Project: 416 John St. - Hyatt House Seattle/Space Needle

Project Number: 3012431 - Design Review Recommendation Packet - April 10th, 2013

Previous Design Review Comments
Meeting was December 19th, 2012

John St. Elevation (South)

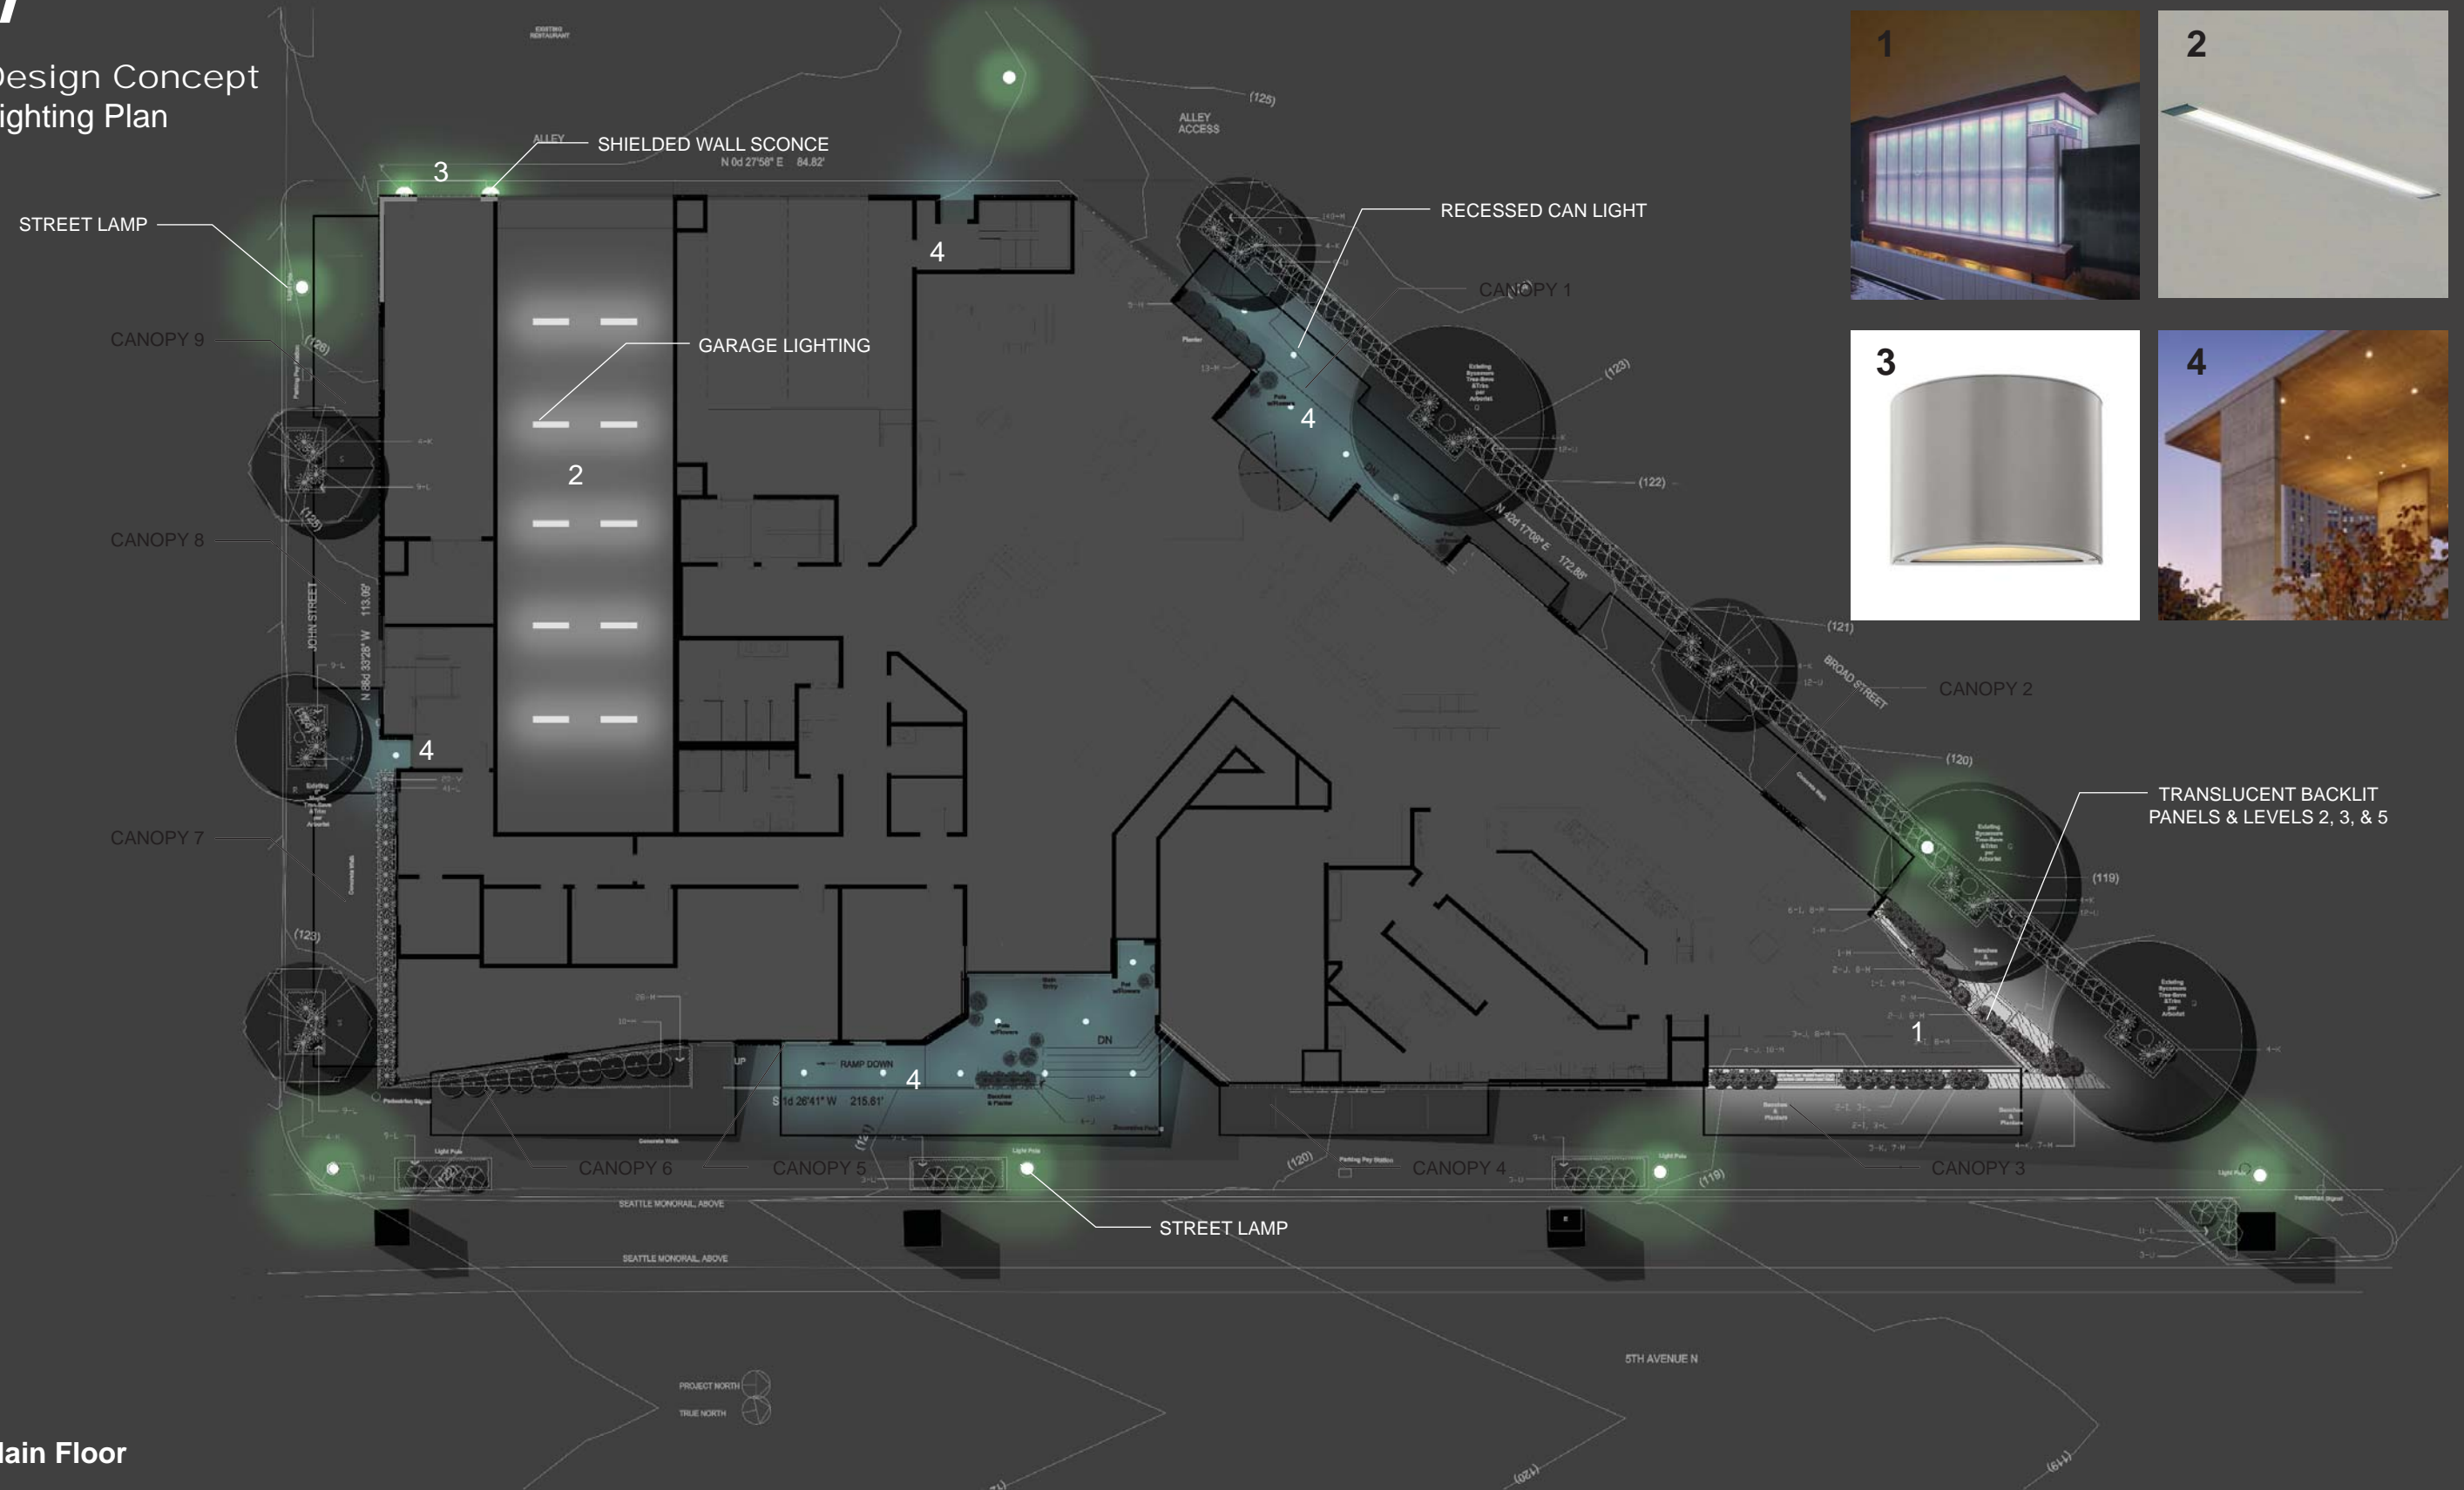
- The John Street elevation should reconsider faux windows where no view of internal activity is possible or feasible. Either rediscover opportunities for actual views into the building at those locations or design creative, artistic or otherwise pedestrian-friendly treatments in those locations to provide the façade interest (even if that requires a minor design departure, which the Board would support) (A-1, A-2, C-1, C-2, C-3, C-4, & D-1).

Departure 3 - Blank Wall

Due to program requirements on the entry level, transparency is not desirable at the trash/recycling area. We propose detailing the wall in an artful, visually interesting pattern that mimics existing art on the Seattle Center campus. The proposed design is a vibrant porcelain or glass tile accent in the field tile.

The elevation will have a facade over thirty (30) feet in width, but less than sixty (60) feet.
